BROWNS FERRY NUCLEAR PLANT - APPENDIX I
 NRC REQUEST FOR ADDITIONAL INFORMATION

Enclosure II Question 2

Topography within 5 mile radius:

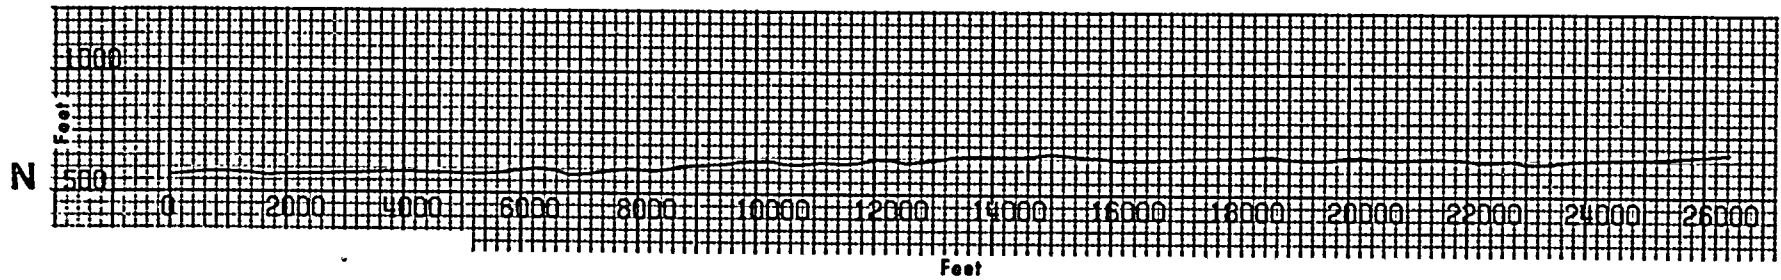
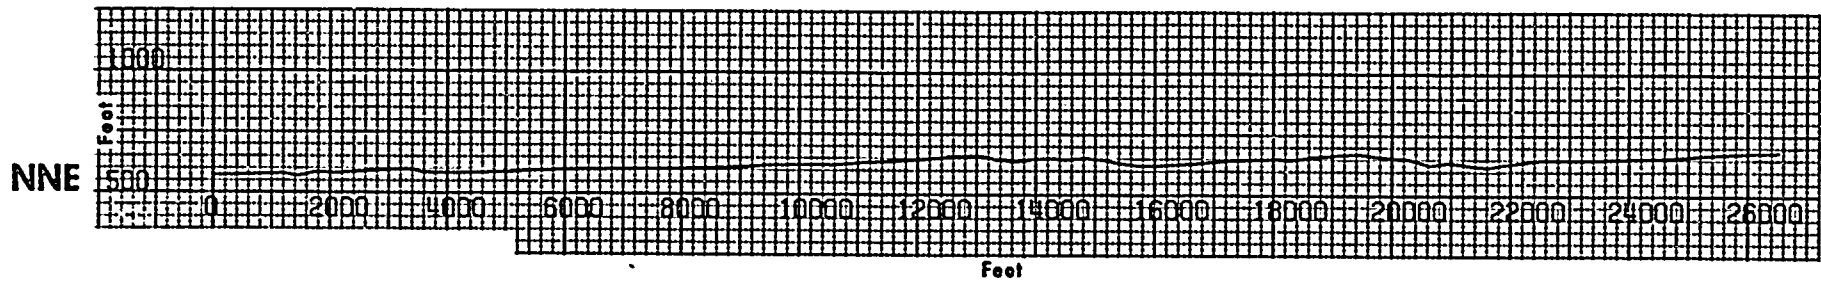
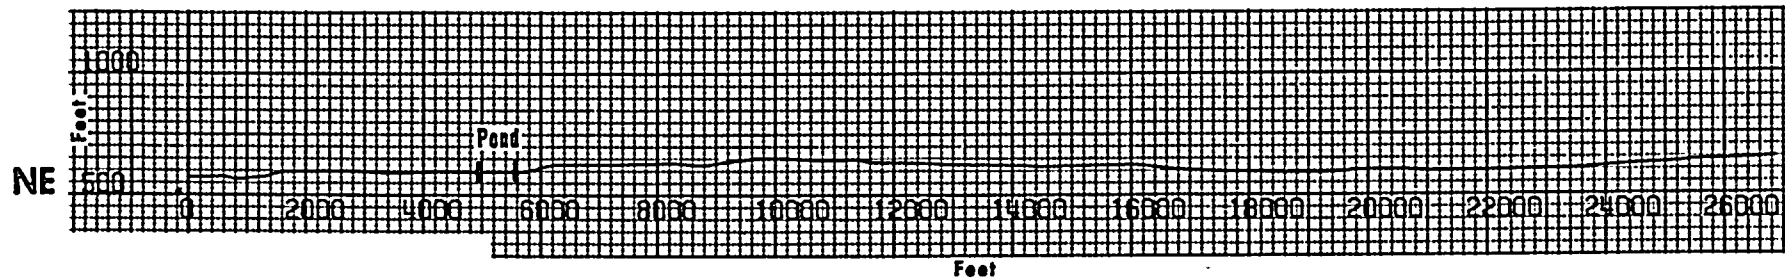
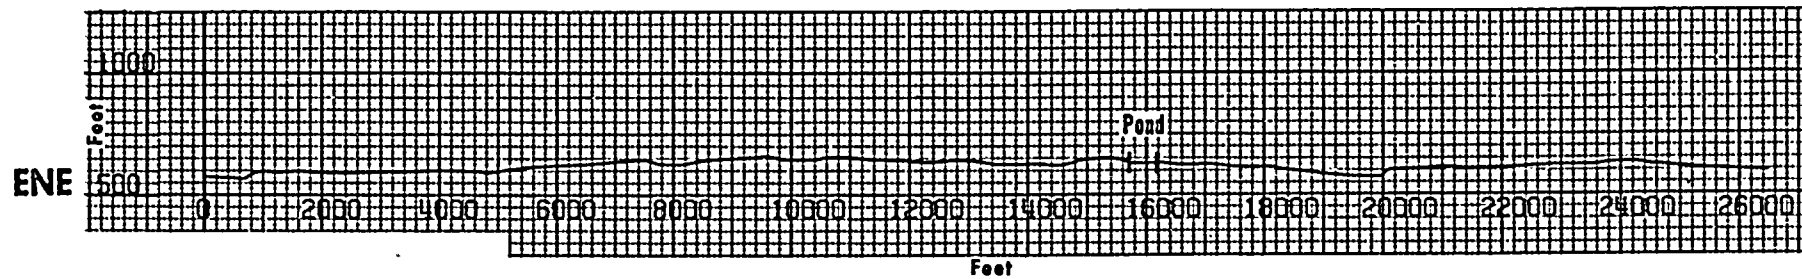
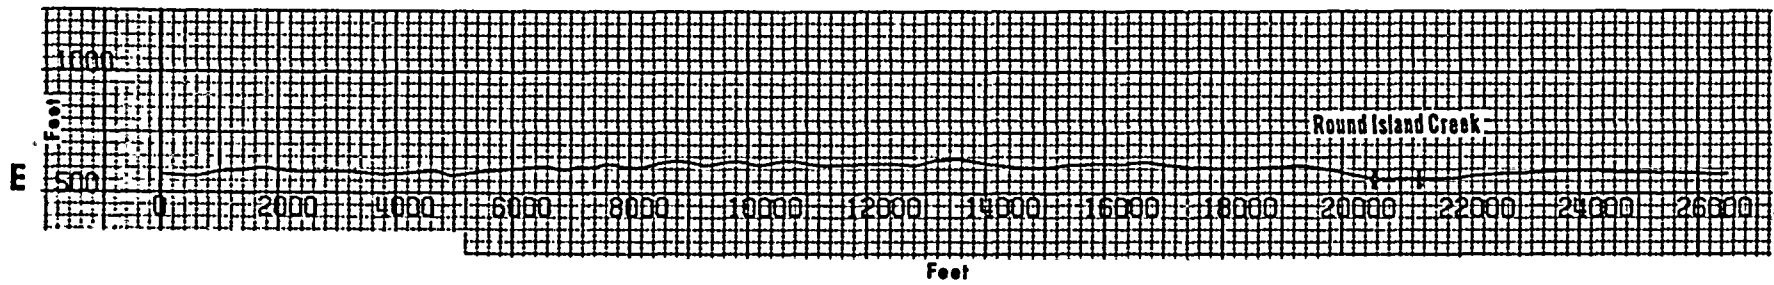
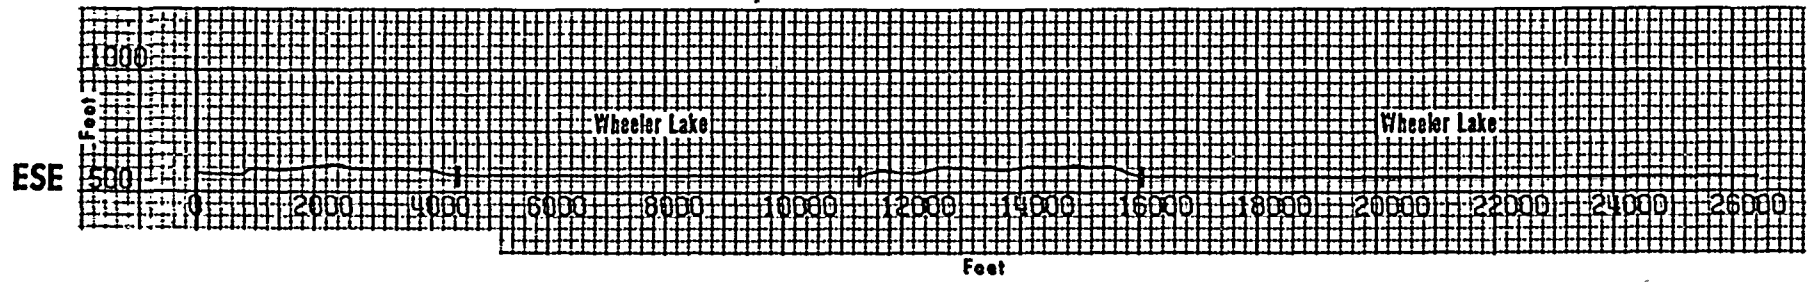
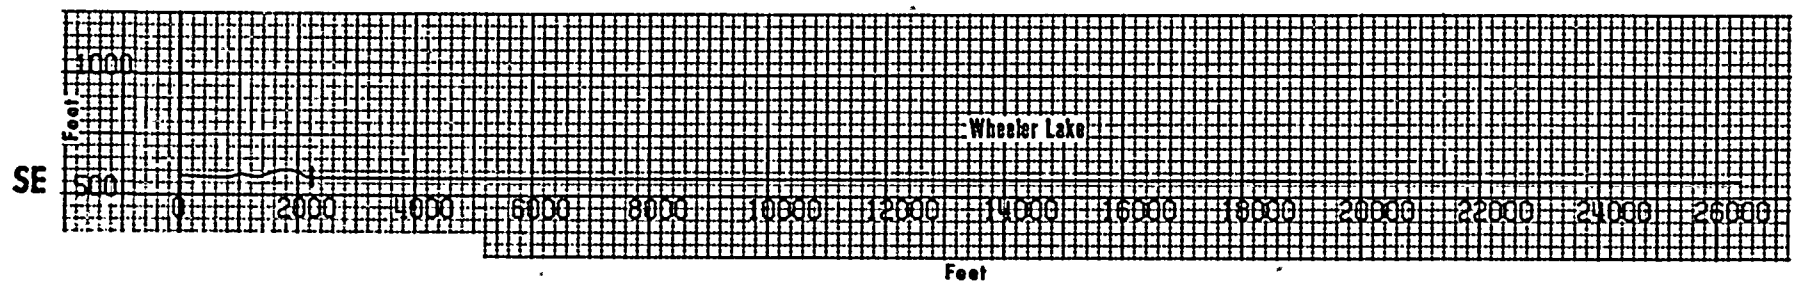
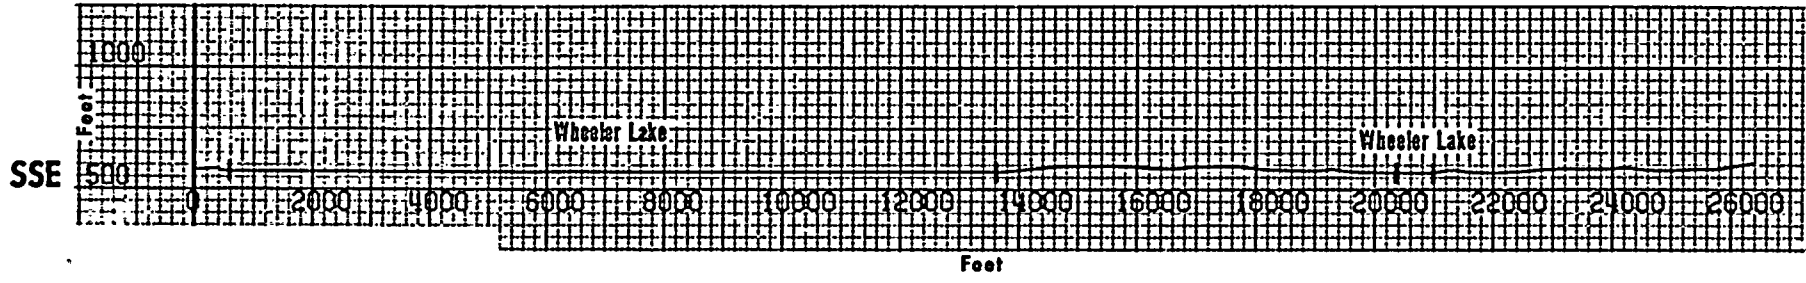
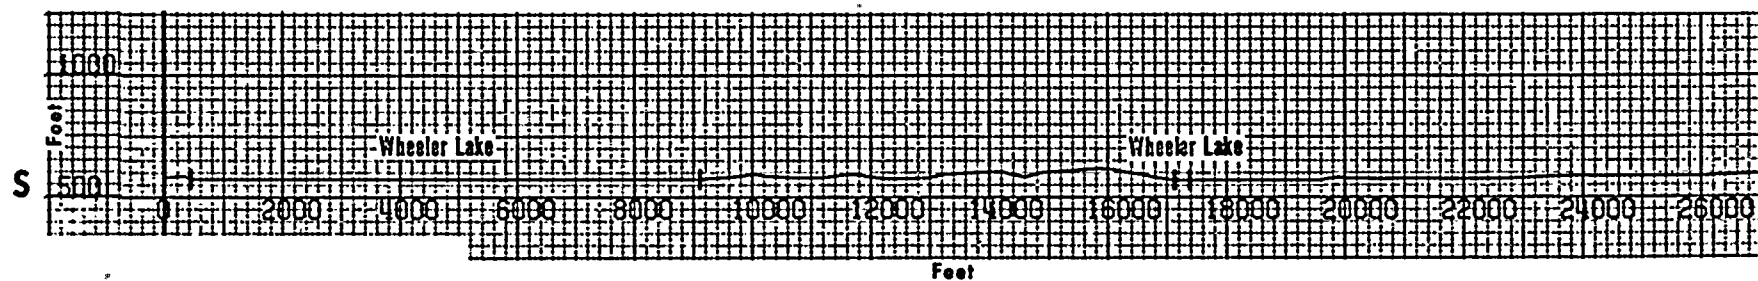
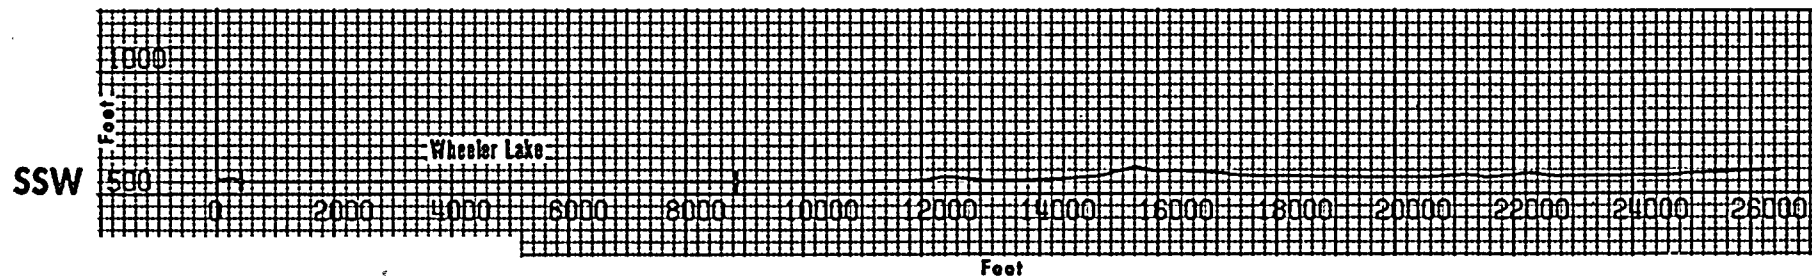
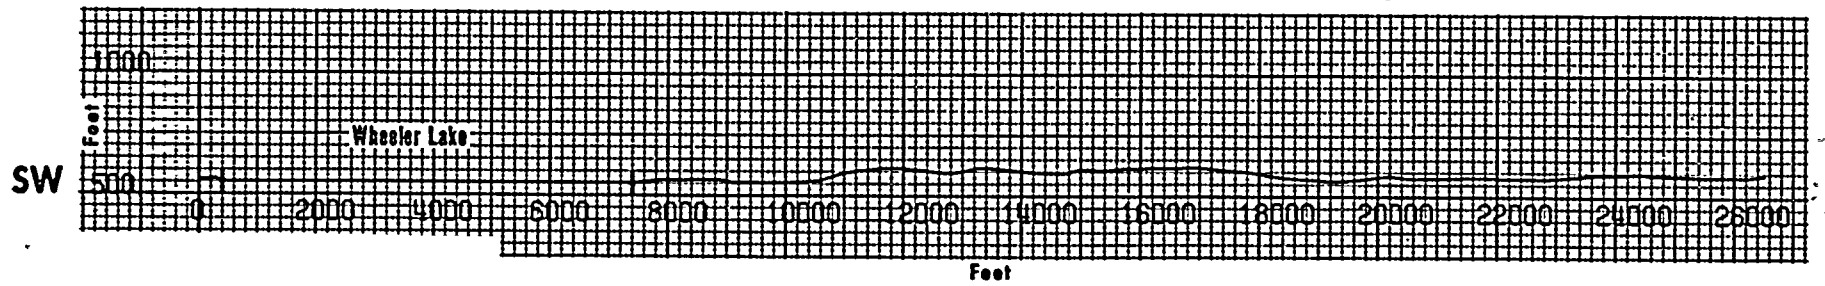
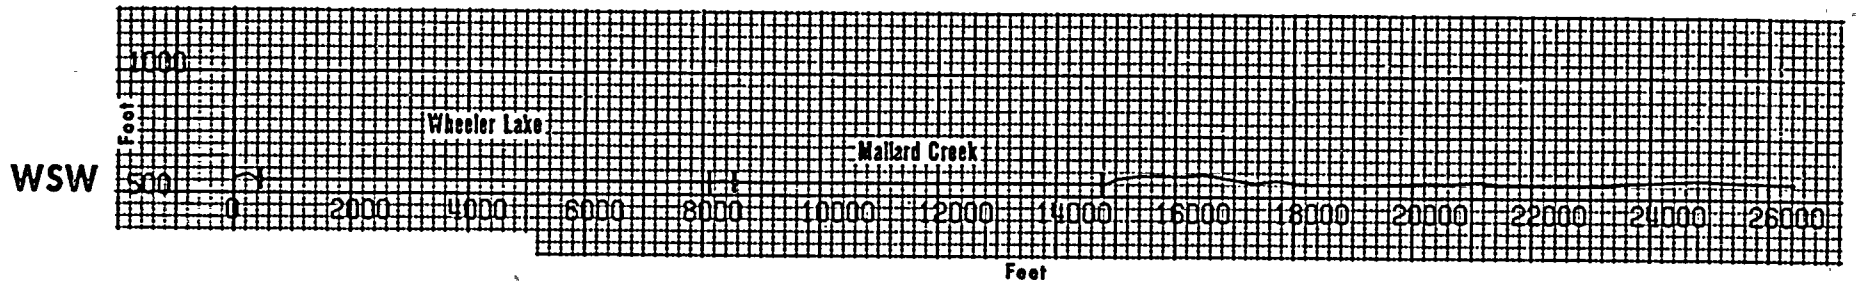
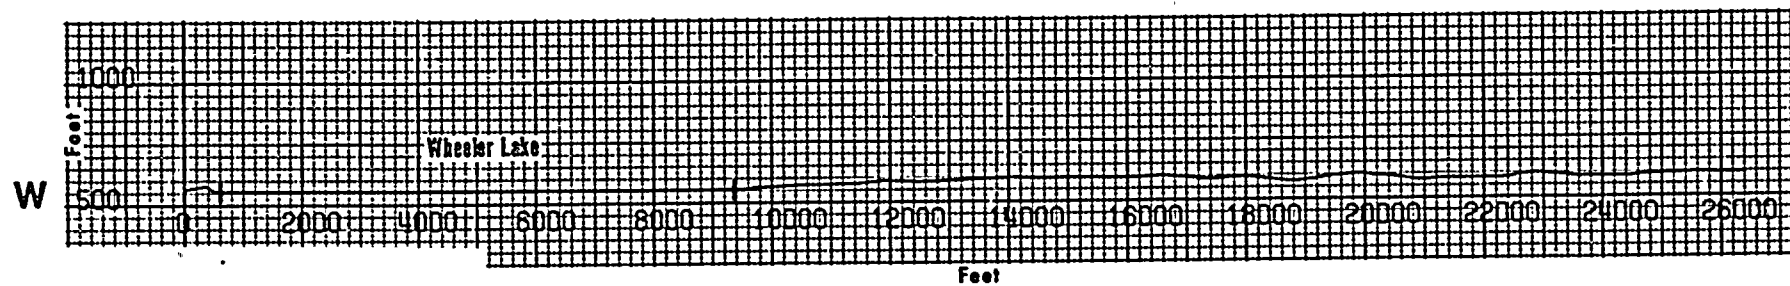
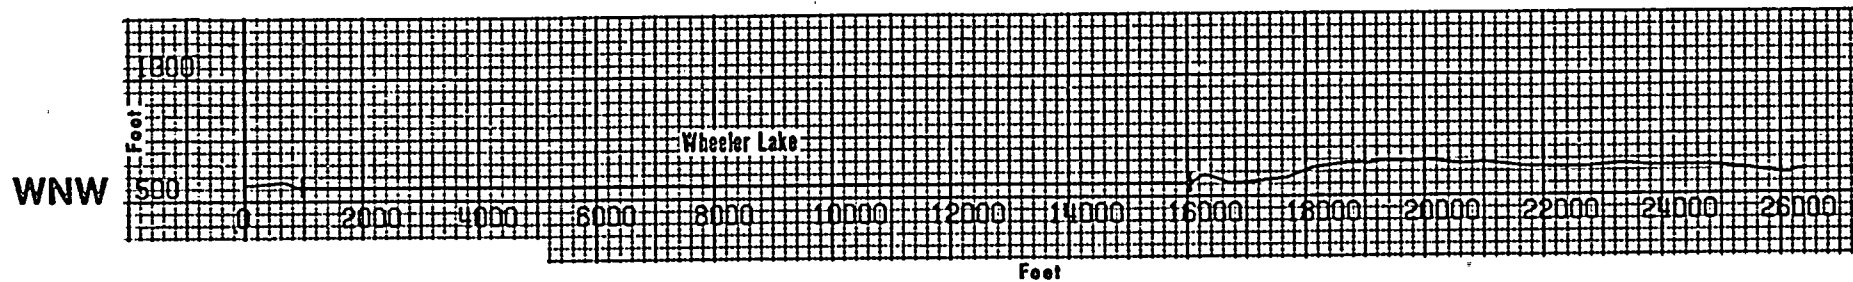
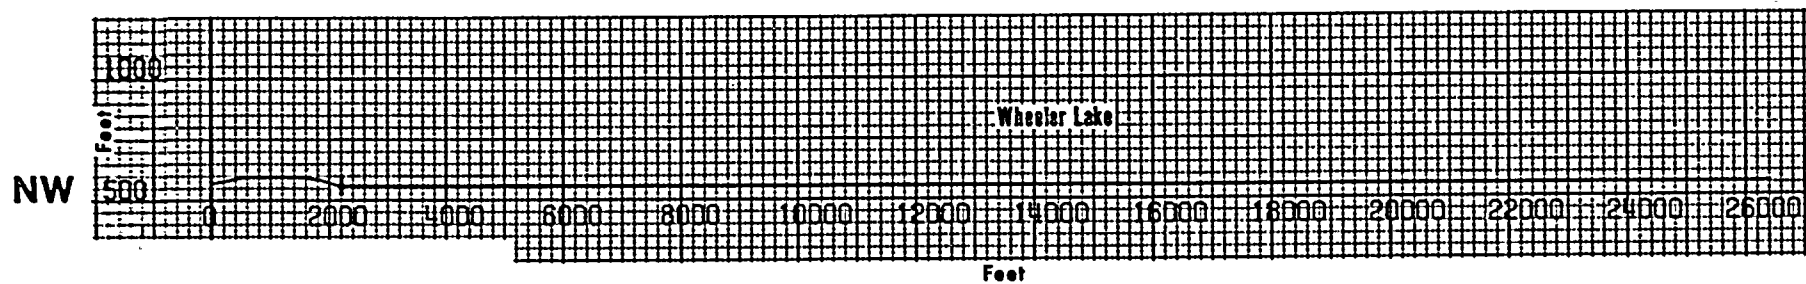
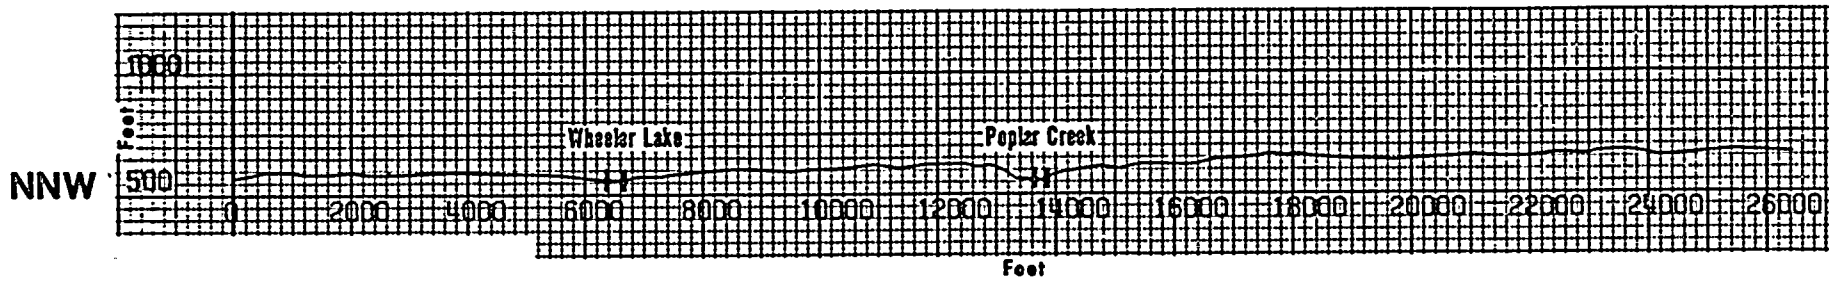
Provide a map showing the detailed topographical features (as modified by the plant, on a large scale, within a 10-mile radius of the plant and a plot of the maximum topographic evaluation versus distance from the center of the plant in each of the 16 22-1/2 degree cardinal compass point sectors (centered on true north), radiating from the center of the plant, to a distance of 10 miles.

A detailed topographical map to a distance of 5 miles is provided. Ground profiles to a distance of 5 miles are also provided.
